Riley Purgatory Bluff Creek Watershed District Permit Application Review

Permit No: 2022-017

Project: Oak Point Elementary Circulation Upgrades - The applicant proposes the reconstruction of the existing driveway, including the addition of a turn lane, and the removal of a paved, overflow parking lot. The modification request is for the site to be considered restricted and replacement of the detention pond and infiltration basin with a biofiltration basin and tree plantings to achieve rate control, volume control, and water quality requirements.

## EROSION CONTROL PLAN

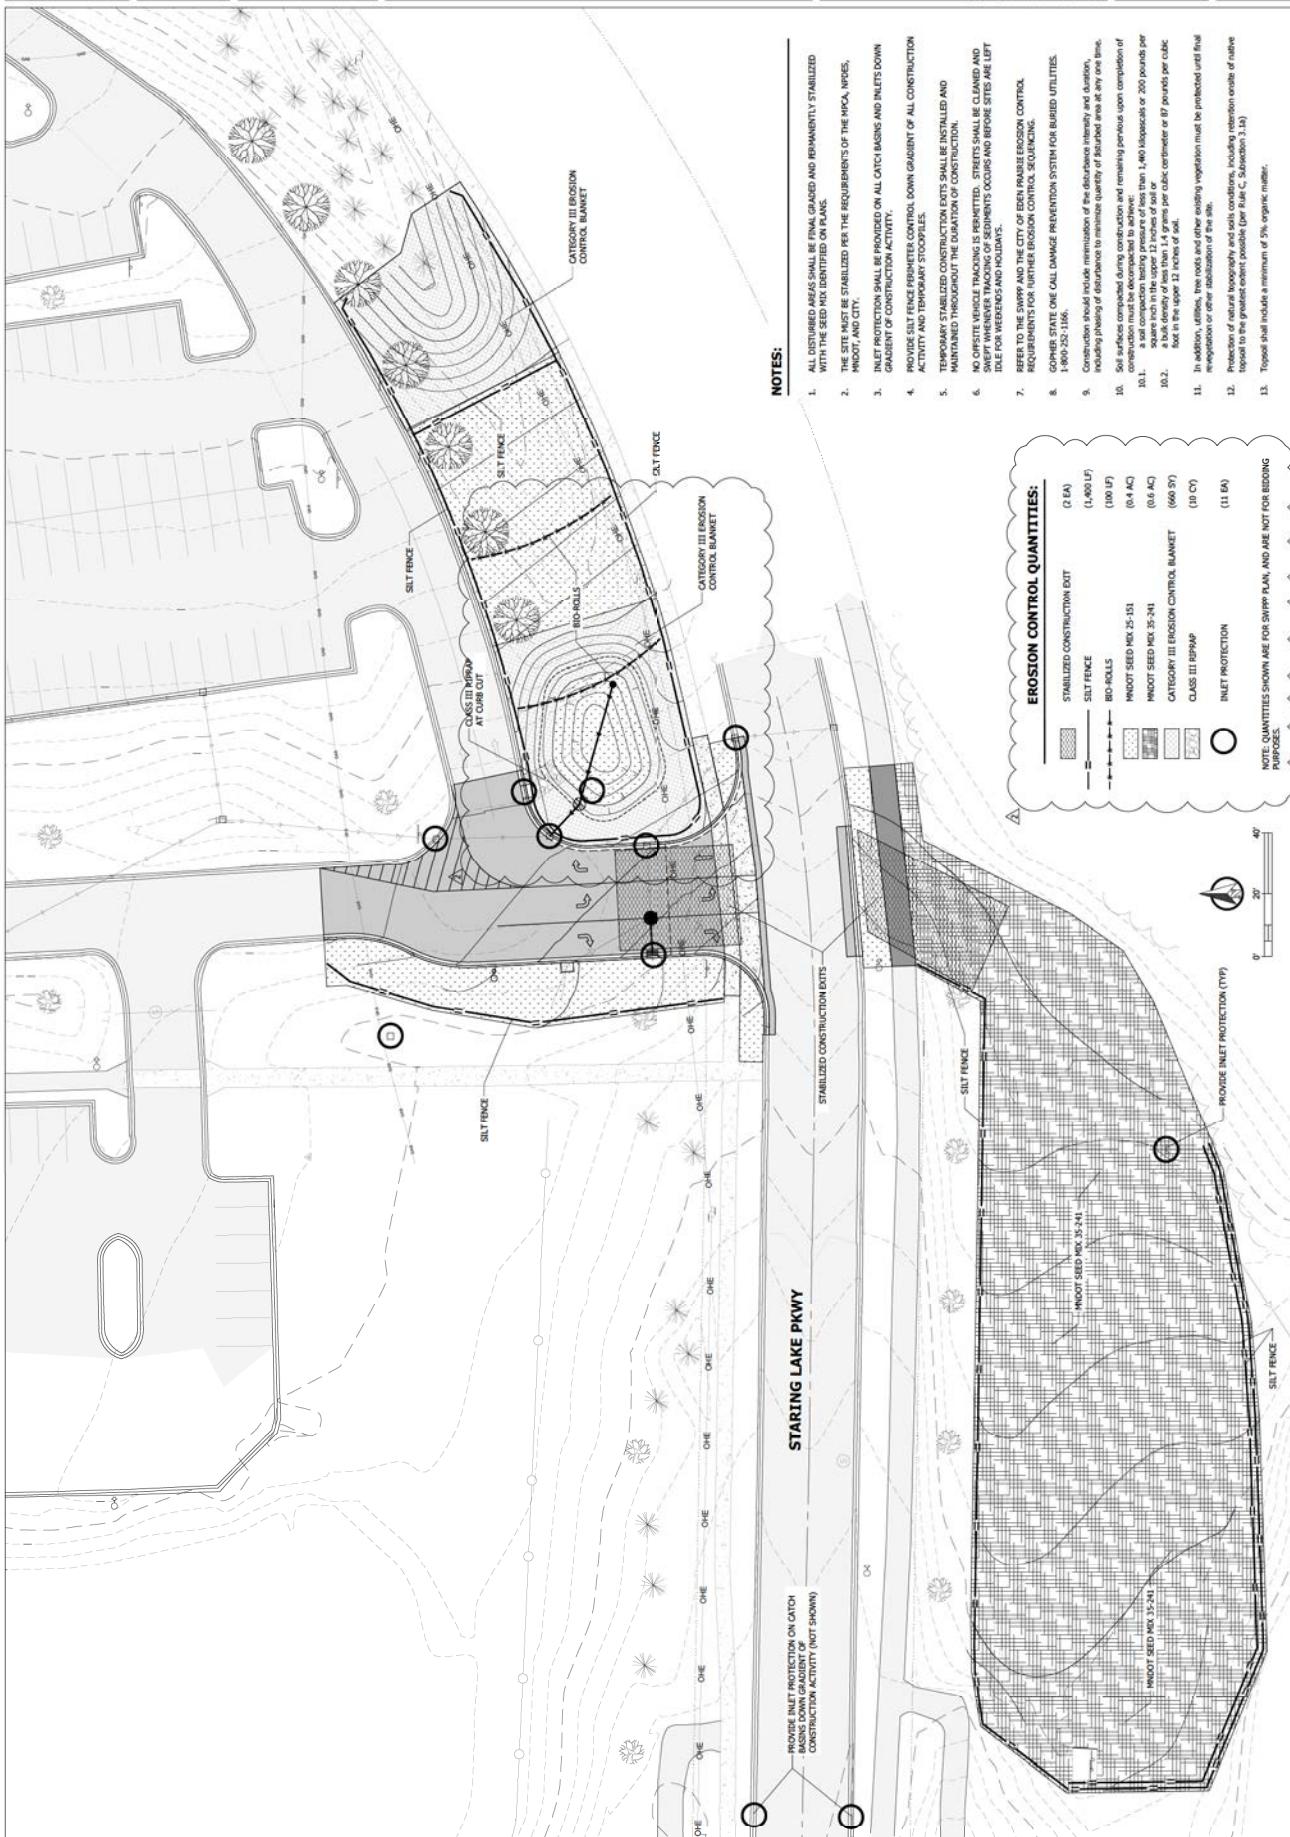
The erosion control plan prepared by Design Tree Engineering includes installation of perimeter control (silt fence and bio-rolls), two stabilized construction entrances, inlet protection, Category III erosion control blanket on disturbed slopes, daily inspection, placement of a minimum of 6 inches of topsoil (at 5% organic matter), decompaction of areas compacted during construction, and retention of native topsoil onsite to the greatest extent possible. To conform to RPBCWD Rule C requirements, the following revisions are needed:

- C1. The Applicant must provide the name, address and phone number of the individual who will remain liable to the District for performance under this rule and maintenance of erosion and sediment-control measures from the time the permitted activities commence until vegetative cover is established.

## TREE PLANTING PLAN

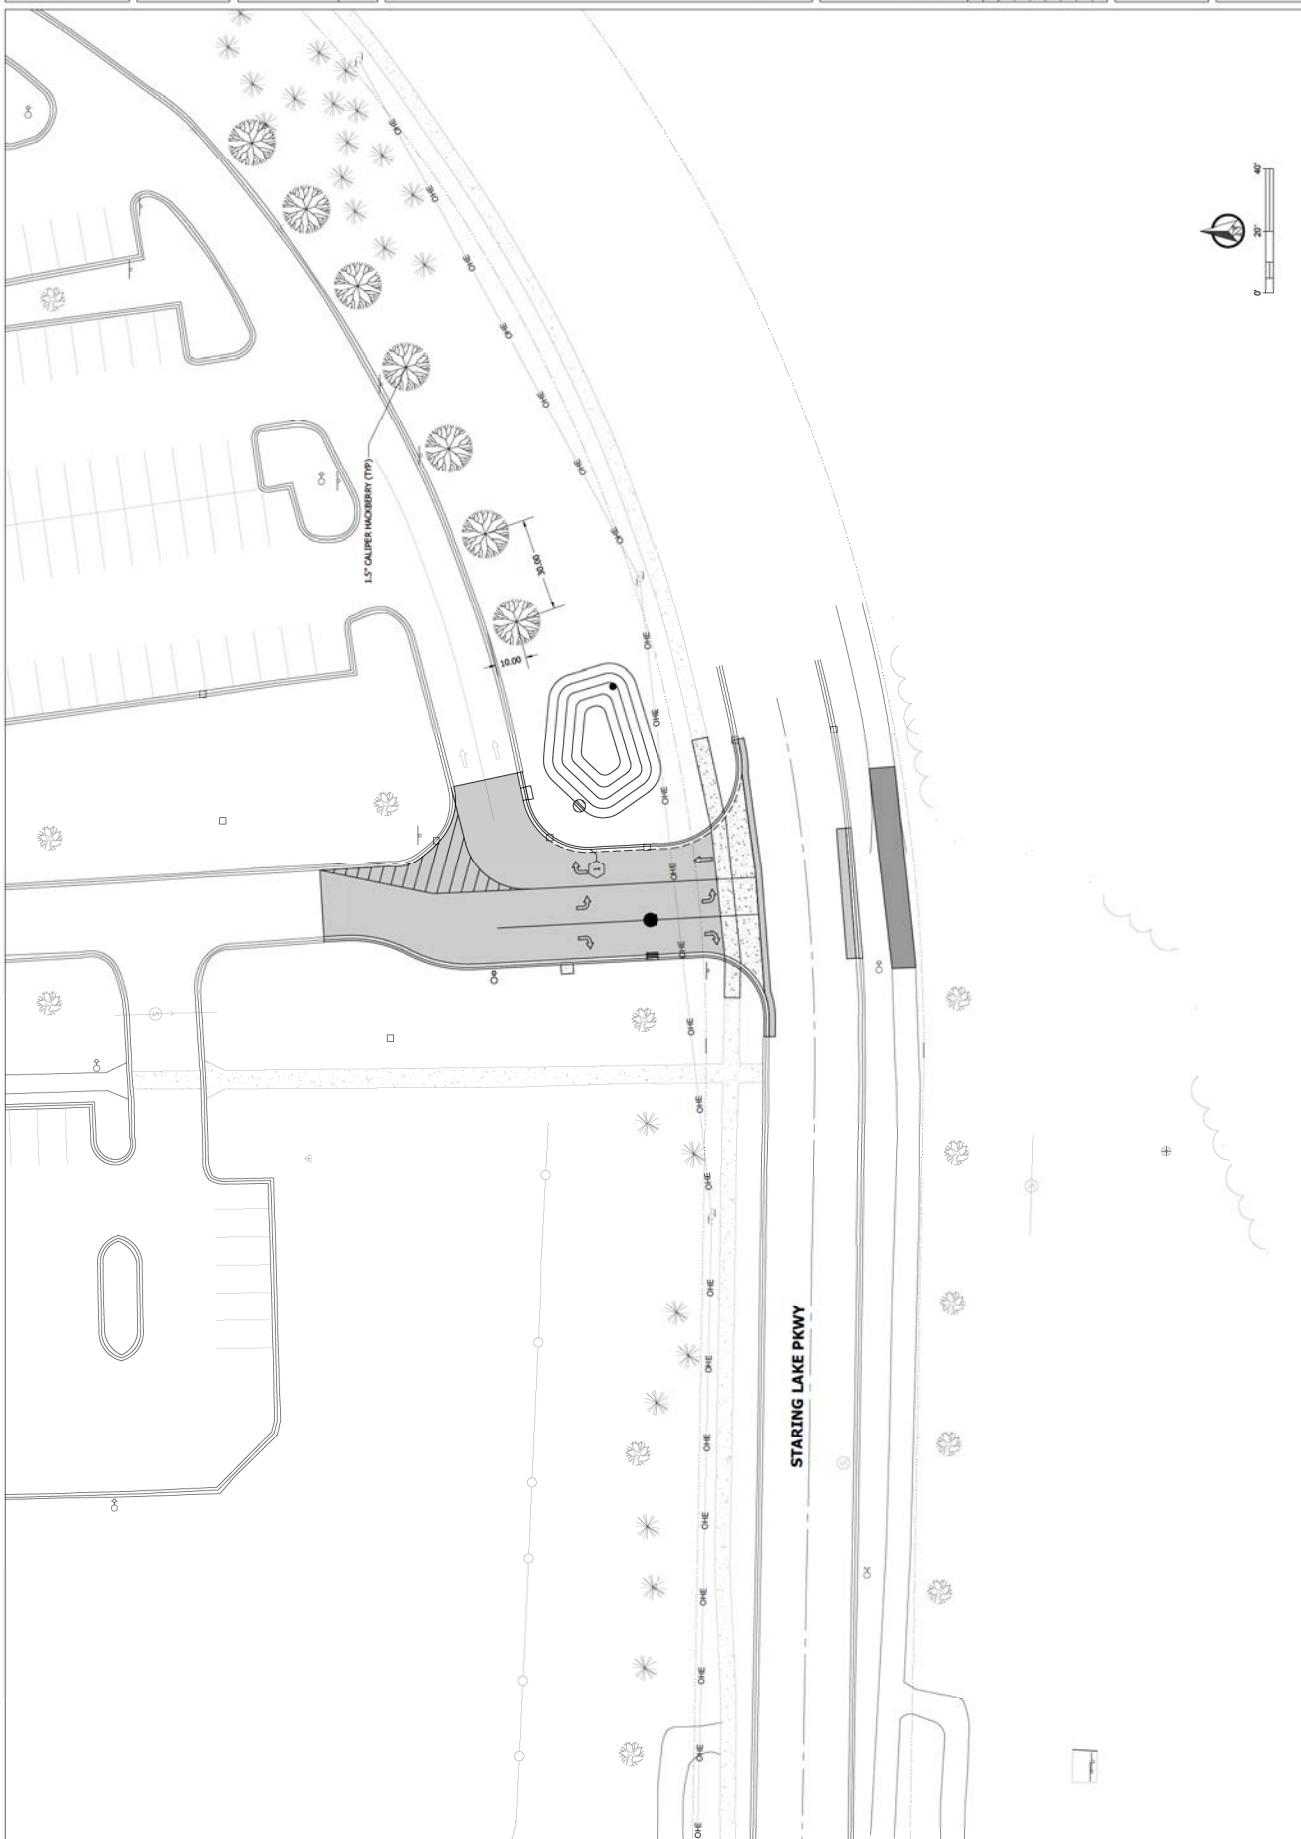
The June 2022 conditionally approved project plans include a detention basin and infiltration basin to achieve rate control, volume control, and water quality requirements. While fulfilling the conditions of approval, further site investigation revealing previous waterproofing measures were implemented by ISD 272 to provide protection from groundwater intrusion into the structure. The engineer concurs the documented groundwater intrusion confirms there is inadequate separation between the seasonally high groundwater level and the low floor of the existing building. The groundwater intrusion information combined with the in-situ infiltration testing showing a rate of 0.0 inches per hour (in/hr), demonstrate infiltration is not feasible and the abstraction standard in subsection 3.1b of Rule J (abstraction of 551 cubic feet of stormwater volume from the 6,002 square feet of regulated impervious area) cannot practically be

met, the site is considered a restricted site and stormwater runoff volume is required to be managed in accordance with subsection 3.3 of Rule J. Because infiltration is not reasonably feasible, the detention basin and infiltration basin proposed in the original application will be replaced with a biofiltration basin with pre-treatment via a Rain Guardian, a concrete chamber used to remove coarse sediment, to provide stormwater quantity and quality control.

Required Abstraction Depth (inches)	Required Abstraction Volume (cubic feet)	Provided Abstraction Depth (inches)	Provided Abstraction Volume (cubic feet)
1.1	511	0.14	67 ¹

¹ Abstraction volume from trees calculated using the Center for Watershed Protection's published Document for *Stormwater Performance-Based Credit. Crediting Framework Product #7 for the project Making Urban Trees Count: A Project to Demonstrate the Role of Urban Trees in Achieving Regulatory Compliance for Clean Water*

TYPICAL INFILTRATION BASIN SECTION

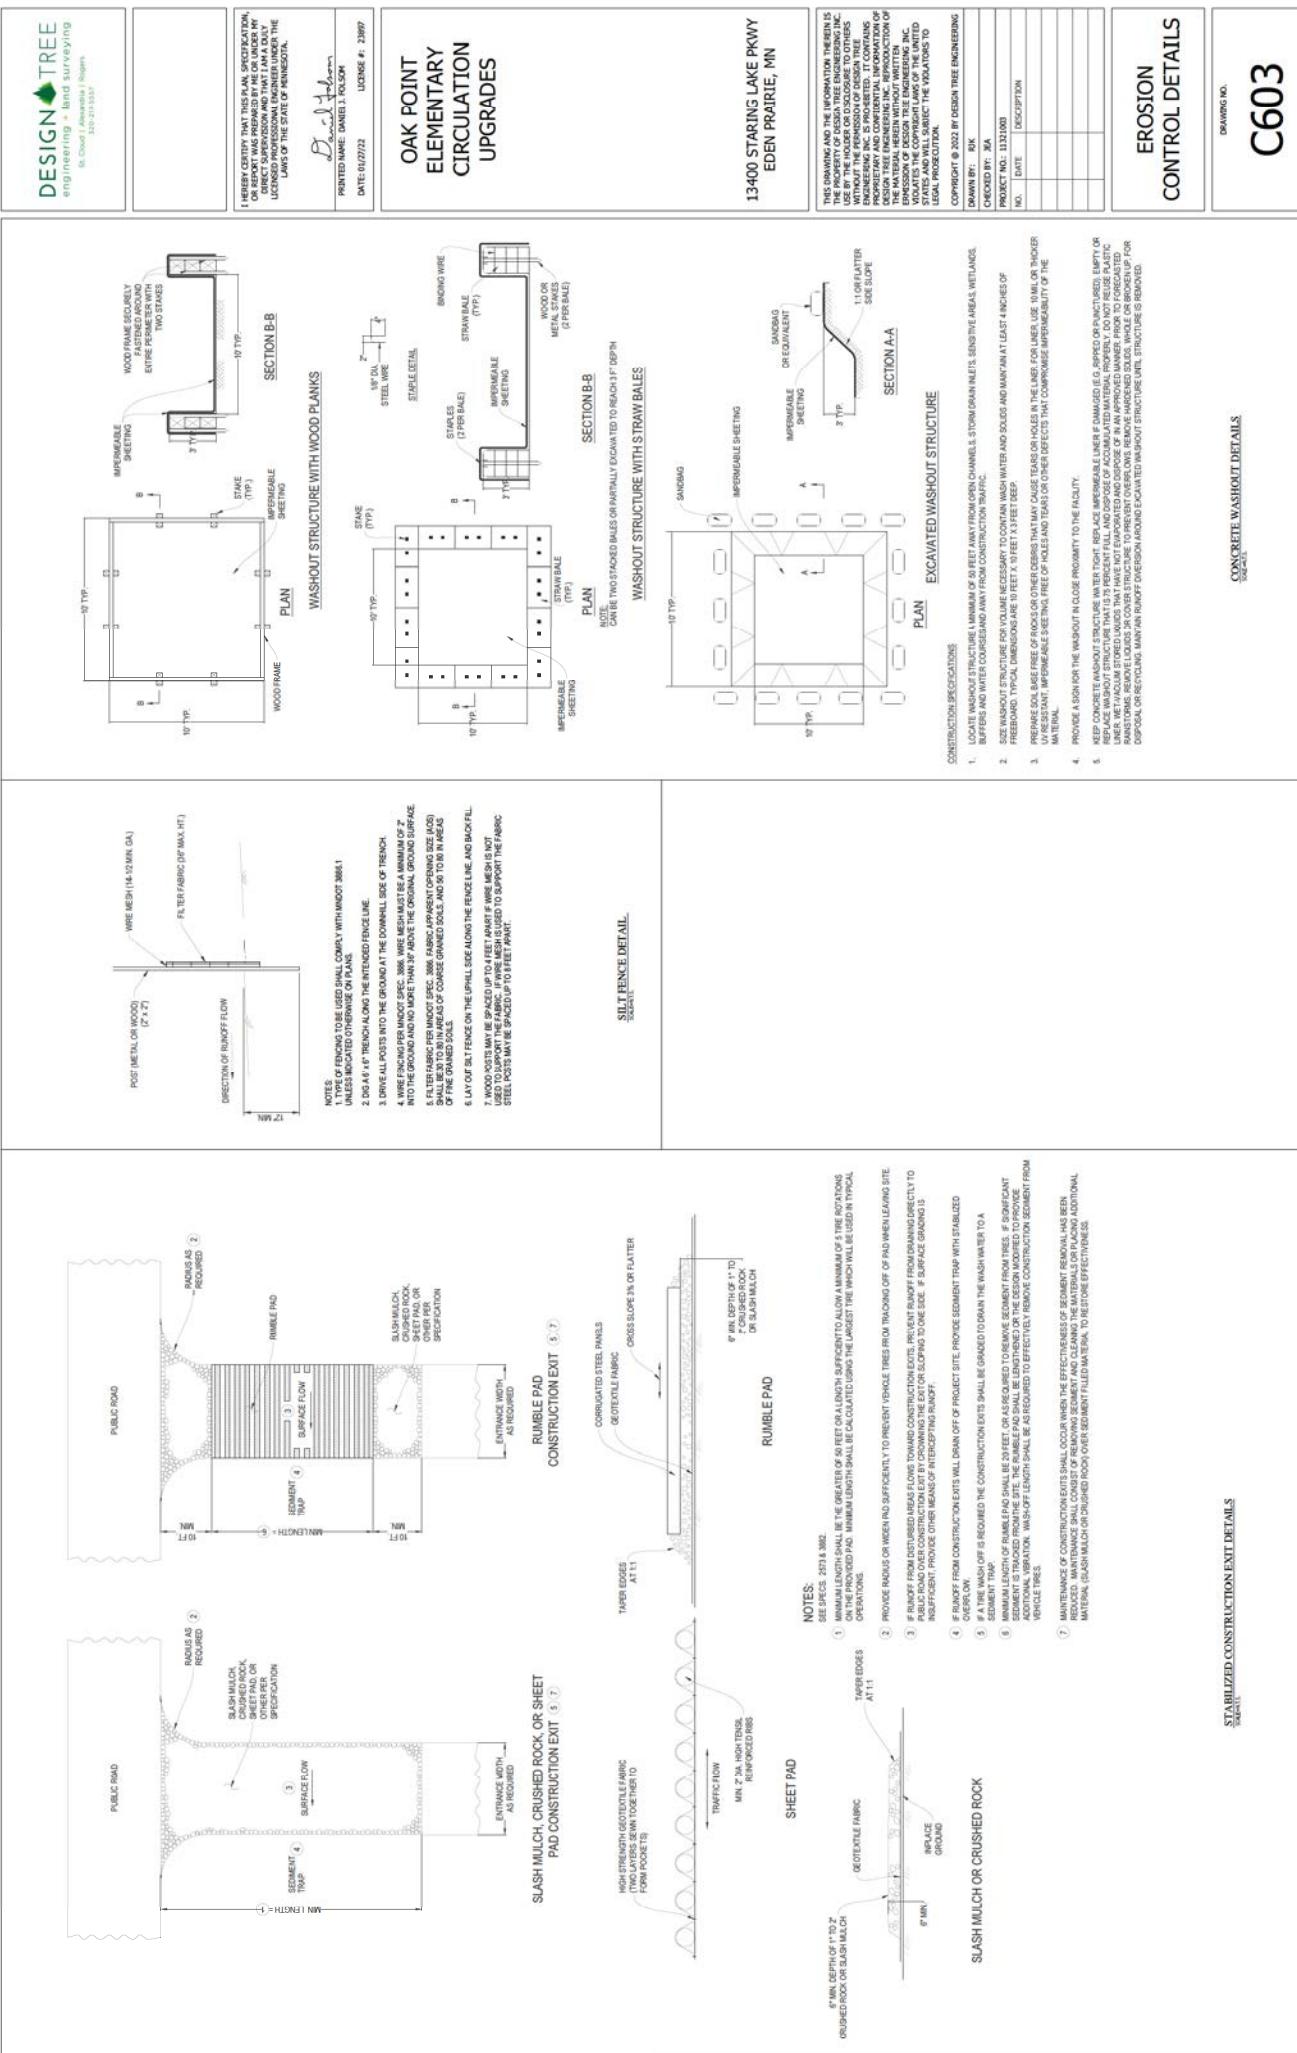
capacity of the soils at the bottom of the infiltration system must be provided. The applicant must submit documentation verifying the infiltration capacity of the soils and the separation to groundwater. If infiltration capacity is less than needed to conform with the volume abstraction requirement in subsection 3.1b or there is inadequate separation to groundwater, design modifications to achieve compliance with RPBCWD requirements will need to be submitted (in the form of an application for a permit modification or new permit).

The downgradient topography and emergency overflow of the proposed infiltration basin are such that the 100-year flow elevation will not be able to inundate areas above elevation 876.5 feet (ie, the basins emergency overflow elevation, and high water flows will be directed away from the existing school building. Because the low floor elevation of the school building to the west of the proposed biofiltration basin is below the emergency overflow of the infiltration basin, the applicant must provide an analysis using *Appendix J1 Plot 1: Minimum Depth to Water Table for No Further Evaluation*, to determine compliance with RPBCWD Rule J, subsection 3.6.b requirements:

- J2. The applicant must submit supporting documentation demonstrating there is adequate separation to groundwater to achieve the low floor criteria with respect to the infiltration basin. If inadequate separation is not provided to conform with the low floor requirement in subsection 3.6b, design modifications to achieve compliance with RPBCWD requirements will need to be submitted (in the form of an application for a permit modification or new permit).

3. The applicant must submit supporting documentation demonstrating there is adequate separation to groundwater to achieve the low floor criteria with respect to the infiltration basin. If inadequate separation is not provided to conform with the low floor requirement in subsection 3.6b, design modifications to achieve compliance with RPBCWD requirements will need to be submitted (in the form of an application for a permit modification or new permit).
4. The applicant submit a draft maintenance and inspection agreement to be submitted to RPBCWD for review and approval prior to execution. The applicant must execute the agreement after approval by RPBCWD.
